Modifications Notices

General Purpose Relay

No. YPE-G2R-7675-2

Modification Notice of the 240VAC Coil ratings change to improve productivity for Power Relay Model G2R-1(A)-T.

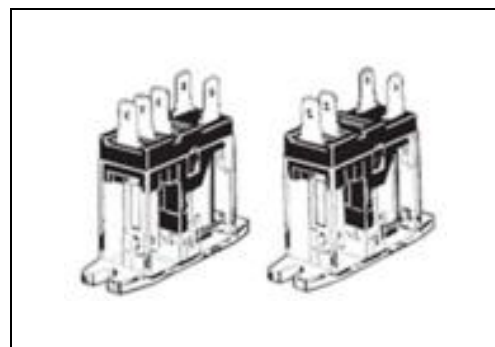
Before the change	After the change
Coil 240VAC	Coil 240VAC
Rated current : 3.2mA(60Hz), 3.7mA(50Hz)	Rated current : 3.7mA(60Hz), 4.2mA(50Hz)
Coil resistance : 30,360 Ω	Coil resistance : 27,800 Ω
Power consumption : Approx. 0.76VA	Power consumption : Approx. 0.9VA
	*Other all AC coil are 0.9VA. *240VAC data sheet is has been described as 0.9VA due to mistake.
